Technical Bulletin

Attention: Elite customers and Rebel customers with split Flap/Aileron Retro kits only.
Subject: Flap-3 and Flap-9

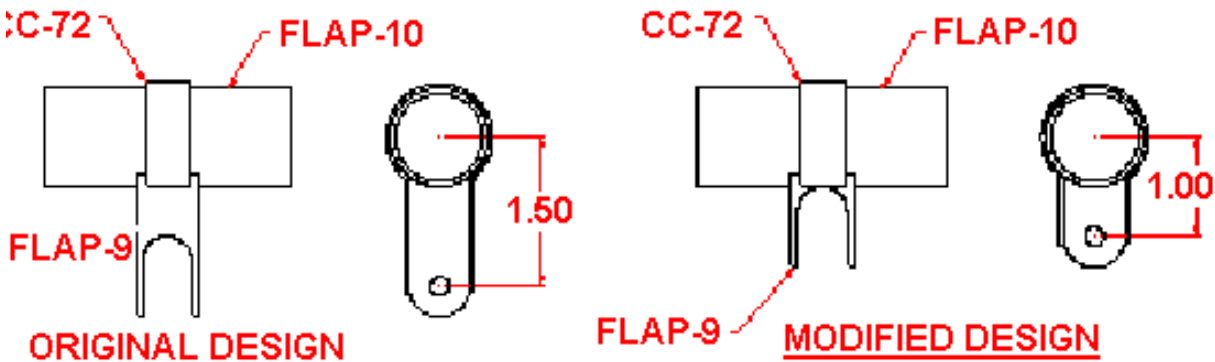
Flap-9 Horn and Flap-3 Aileron-Flap Horn Assembly have been modified as per the figures shown below. We believe that everyone affected is aware of the change and has received modified parts or are making the required changes themselves. The centre to centre distance has been reduced from 1 1/2" to 1". This change was made to reduce the amount of droop in the ailerons when the flaps were applied. This improves aileron response at full flaps.
